## Cycle Enfield - Section 1

### A105 South of Ecclesbourne Gardens to Oakthorpe Road

Stage 2 Road Safety Audit

Ref: 2759.03.01/032/A105/BOR/2016

### **Problem Locations**

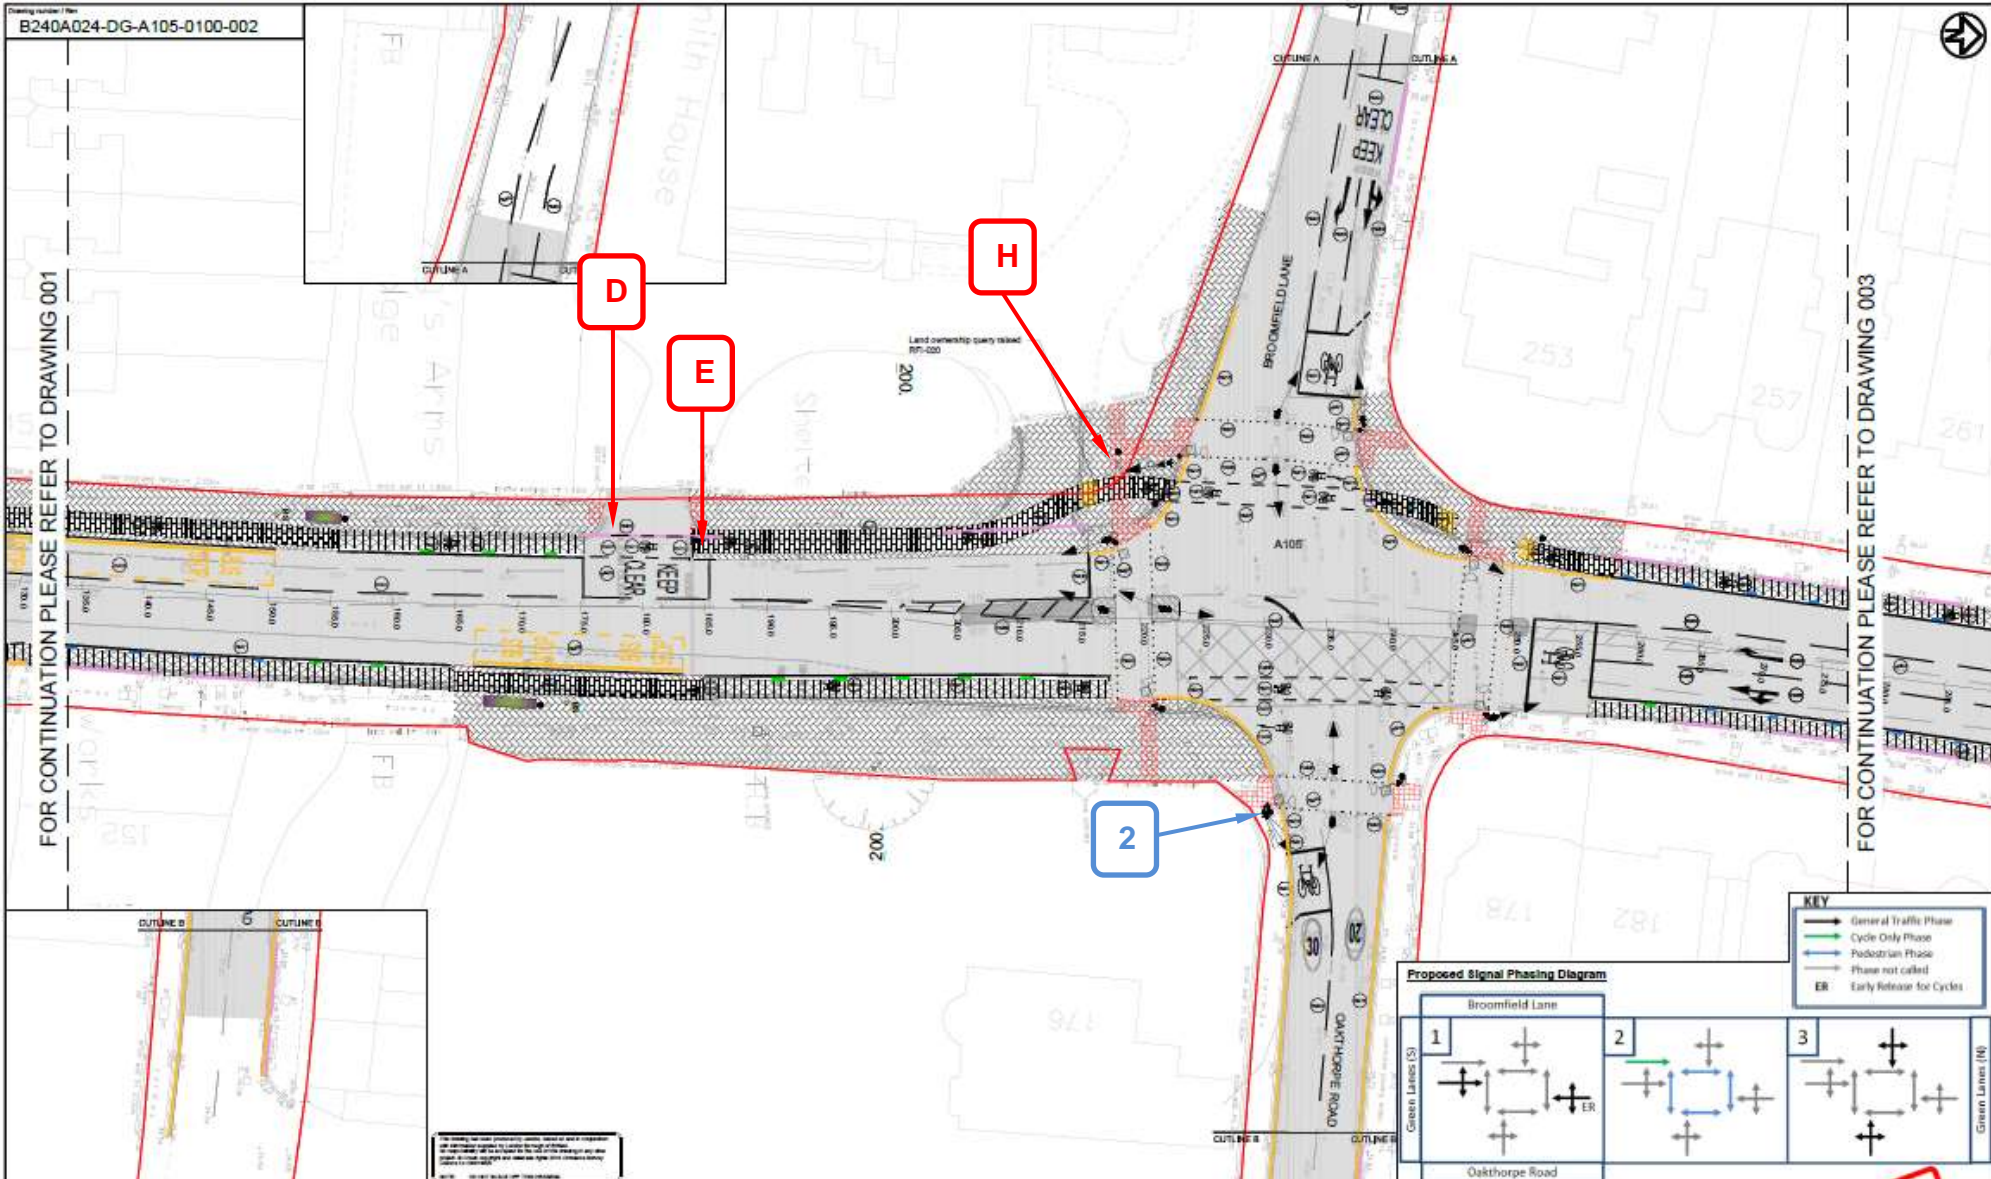
**Location:** A – A105 Green Lanes junction with Ecclesbourne Gardens

**Summary:** Lack of cycle facilities past this junction may lead to an increased potential for collisions with cyclists

The Audit Team are concerned that southbound cyclists do not appear to have any onward provision beyond the shared cycle / Zebra crossing to the north of Ecclesbourne Road. It is therefore not clear what cyclists will do if they continue southbound, this may lead to cyclists making various manoeuvres which may be less obvious for motorists to anticipate. The Audit Team are concerned for example, that motorists entering or exiting Ecclesbourne Gardens may see southbound vehicles stopped at the Zebra crossing and start to turn across the southbound lanes and are unlikely to anticipate a cyclist re-entering the carriageway to continue southbound via the shared use cycle / Zebra crossing. This may lead to an increased potential for vehicles to turn across the path of cyclists continuing southbound on the carriageway.

**Location:** B – A105 Green Lanes, cycle lane across petrol station access

**Summary:** Cycle track width may be insufficient

The proposed cycle track appears to narrow as it crosses the petrol station access. As the horizontal and vertical alignment changes at this location, a narrowed facility in combination with changing direction and elevation may result in difficulties for some cyclists to stay within the facility. If cyclists struggle to stay within the cycle track they may slow down across the petrol station access which might not be anticipated by vehicles following and attempting to enter the petrol station or they may swerve into the path of another user or be destabilised.

**Location:** C – A105 Green Lanes, cycle lane across petrol station access

**Summary:** Semi segregated cycle lane terminates just before this busy vehicular access which may increase left turning collisions between vehicles and cyclists

The proposed semi segregated cycle lane terminates just before this busy access. At such locations it may be difficult for both sets of road users to understand who has priority and this may lead to turning collisions involving cyclists. Cyclists may not anticipate a vehicle turning across their path and may find it difficult to avoid such vehicles in close proximity. This may lead to an increased risk of left hook / failure to give-way type collisions between southbound cyclists and vehicles crossing the track to use the access.

**Location:** D – A105 Green Lanes south of junction with Broomfield Lane

**Summary:** Proposed cycle lane may be obstructed as drivers enter this development which may result in cycle collisions

The proposals include a break in the mandatory semi-segregated cycle track to facilitate access to this residential development. The Audit Team are concerned that as the development is gated vehicles waiting for the gates to open are likely to obstruct the cycle track. Cyclists wishing to maintain progress may therefore swerve around the waiting vehicle into the carriageway where they may not suitable sight or be sighted by northbound motorists, particularly due to the crest in the vertical alignment and potential for the bus stop shelter / a waiting bus to reduce intervisibility. This may therefore result in an increased potential for collisions between northbound cyclists and vehicles whilst motorists use this access.

**Location:** E – commencements of full height kerbs south of Broomfield Lane

**Summary:** Motorists may not notice and collide with the commencement of a full height kerb

The Audit Team are concerned that motorists may not appreciate that the edge of the cycle track includes a full height kerb at this location. This kerbed physical segregation commences within the carriageway running lane and it may not provide suitable features to highlight this physical feature or guide users alongside it. It may therefore, not be clear or conspicuous. Motorists may collide with the kerb or swerve to avoid the features if they are noticed within close proximity, which may result in loss of control type collisions / injury to those on or within the vehicle.

**Location:** F – A105 Green Lanes between Ecclesbourne Gardens and Palmerston Crescent

**Summary:** Proposed Zebra and cycle crossing layouts may result in drivers failing to give-way to cyclists

The Audit Team are concerned that the proposed Zebra and cycle crossing may not be understood by motorists particularly as the layout is new to drivers. The following issues may result in an increased potential for collisions:

**Location:** G – A105 Green Lanes proposed Zebra crossing between junctions with Palmerston Crescent & Ecclesbourne Gardens

**Summary:** Proposed Zebra crossing facility may result in an increased potential for collisions

The southbound carriageway effectively widens to two lanes on approach to the proposed Zebra crossing facility. The Audit Team are concerned that southbound motorists entering the offside lane, effectively overtake vehicles in the nearside lane. These motorists may not clearly see the crossing and may suddenly encounter it as they accelerate past another vehicle. Particularly given that the two lane section quickly returns to a single general traffic lane whilst the bus lane is in operation. The potential for motorists to not notice the Zebra crossing may be exacerbated as the belisha beacons on either side of the carriageway could be obscured by queuing vehicles. If users do not suitably observe the crossing facility they are unlikely to give-way to users in the crossing, particularly cyclists as this part of the crossing is encountered first and less conspicuous than the established Zebra crossing.

**Location:** H – A105 Green Lanes junction with Broomfield Lane

**Summary:** Proposed layout may result in conflicts between pedestrians and cyclists

The northbound cycle route transitions to a segregated on-footway facility on the approach to Broomfield Lane. As this facility reaches the crossing point for eastbound or westbound pedestrians on the southern side of Green Lanes, it appears to become a shared use facility. The Audit Team are concerned that cyclists attempting to make it past the stop-line before the end of an indicated green phase may be reluctant to slow down and this may not be expected for pedestrians who cross within the same phase.

**Location:** 1 – A105 Green Lanes junction with Ecclesbourne Gardens (Sheet 1/47)

The proposals include retention of the existing bus lane signs to the south of this junction. Technically, as the bus lane re-starts at this location this should have altered signing on the approach and at the commencement point to warn and notify users of its presence.

**Location:** 2 – A105 Green Lanes junction with Oakthorpe Road (Sheet 2/47)

The proposals include alterations to the kerb line and location of the traffic signal pole which may result in a narrow effective footway width on the southern footway of Oakthorpe Road.

The cycle scheme has ended at this point. Southbound cyclists are directed towards the parallel crossing so that they can continue travelling south.

Design Organisation Response	Accepted / Part Accepted / Rejected
The cycle track at this point has a width of 1.4m. This is due to the brick wall at the petrol station boundary which creates a pinch point. To maintain a footway width of 1.8m for pedestrians it is not possible to further widen the cycle track. The minimum recommended width for a one-way cycle track is 1.5m. However, this minimum allows for a cyclist to overtake another cyclist. As this section is approaching the end of the route and southbound cyclists must cross at the parallel crossing, cyclist speeds will be at a minimum and no overtaking should occur as this is also a short section. Therefore, 1.4m cycle track width at this section is acceptable.

<b>Design Organisation Response</b>	<b>Accepted / Part Accepted / Rejected</b>
TRL (PPR703 – Trials of segregation set-back at side roads) states that bringing segregation very close to the turning manoeuvre (<5m) combines both the merging conflict and the turning conflict into a single manoeuvre, requiring only one decision for the driver: whether or not to turn. Vehicle speeds are also likely to be slower due to the sharper angle required to turn into the junction, giving the driver more time to make the decision, and the approach angle closer to the perpendicular, placing approaching cyclists more directly in the driver's line of vision. The semi segregation ends 4.5m from the junction.	
<b>Client Organisation Comments</b>	
Designer's response accepted.

Design Organisation Response	Accepted / Part Accepted / Rejected
The edge of the cycle lane is approximately 5-6m setback from the gate which is sufficient for a large vehicle to wait without obstructing the cycle lane.	
Client Organisation Comments	
Designer's response accepted.

Design Organisation Response	Accepted / Part Accepted / Rejected
On the approach to the location the cycle lane is marked with line of Orcas, so motorists should already be in the correct alignment. Line marking to diagram no. 1010 has been used to delineate the edge of carriageway. This line marking will also

This type of crossing appears in the new TSRGD which came into force on the 22nd of April 2016. We refer to page 476 Sign table Item 53, Schedule 14, Part 2 in the new TSRGD document. The crossings are proposed for the A105 as well as other major corridors as part of Cycle Enfield so will be common within the borough of Enfield within the next few years. The crossings have been sited at locations where a Greenway is intersecting with the A105 corridor and crossing facilities are required to safely link the routes. Signage will be introduced following implementation, so that all road users will be aware of the proposed crossings.

Design Organisation Response	Accepted / Part Accepted / Rejected
<p>The double lane opens up on the approach to a ramped Table, which will act as a visual warning to slow down.</p> <p>A lack of carriageway space prohibits inclusion of a central island to accommodate an additional belisha beacon.</p>	
Client Organisation Comments	
<p>Designer's response accepted – operation of the crossing will be monitored post-implementation.</p>

Design Organisation Response	Accepted/ Part Accepted /Rejected
<p>The area in question is shared space and, as such, cyclists have a duty to give way to pedestrians. Rearranging the crossings is not a viable option due to space limitations and it would also disturb the cycle routes continuity.</p> <p>The cycle track is offset from the east west pedestrian crossing and pedestrians and cyclists have good forward visibility of each other.</p> <p>The cycle phase is an 'ahead only'. However, should cyclists decide to turn right they will sit in the pocket on the north side of the crossing until Broomfield Lane gets a green signal. Line markings to highlight the 2SRT have been clearly marked on the carriageway. Consideration could be given to introducing a 2 stage sign to reinforce this (as used by TfL on CSH).</p>	
Client Organisation Comments	
Designer's response accepted – operation of the bus stop boarders will be monitored post-implementation.

Design Organisation Response	Accepted / Part Accepted / Rejected
Signage has been altered to correctly relate to the proposed layout/bus lane road markings.	
Client Organisation Comments	
Designer's response accepted

Design Organisation Response	Accepted / Part Accepted / Rejected
At the traffic signal pole there is an effective footway width of 1.5m which complies with the minimum acceptable width due to physical constraints.	
Client Organisation Comments	
Designer's response accepted
